CK III II2 II2 inv_1x oUT clkb IN Sica_v2_EL vm vm

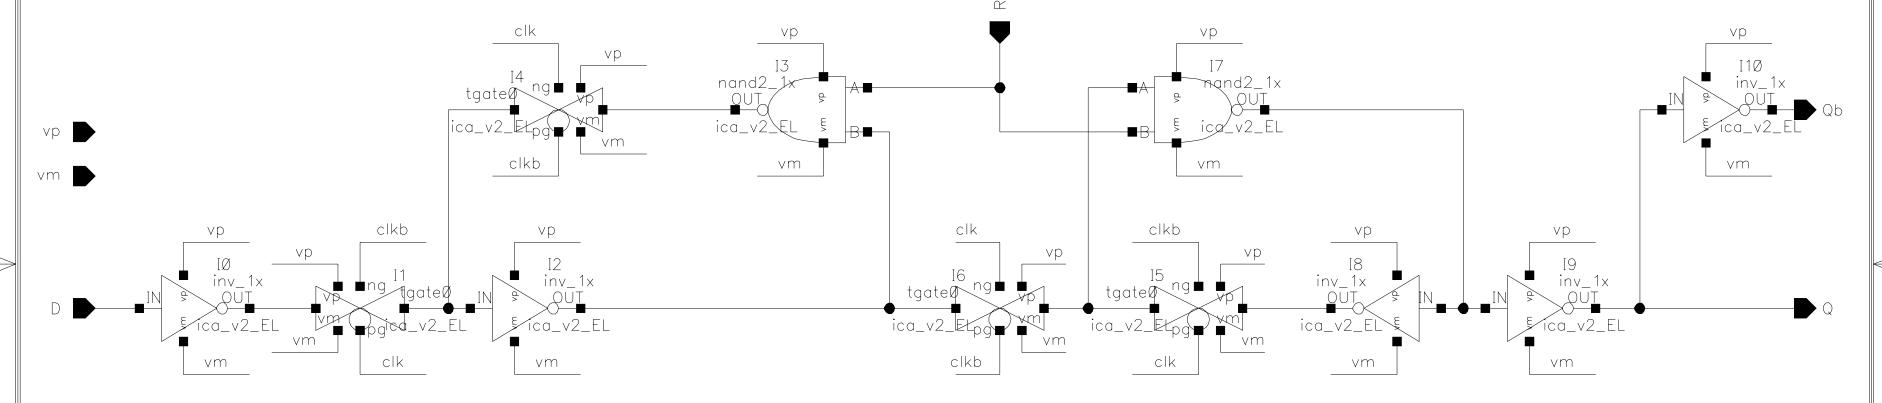
Asynchronous RN sets Q=logic "Ø" NEED clock to be HIGH TO hold this value!!

flip I4 sideways to interchange "a" and "b" terminals

Interchange I5 and I6, then flip each sideways to interchange "a" and "b" inputs.
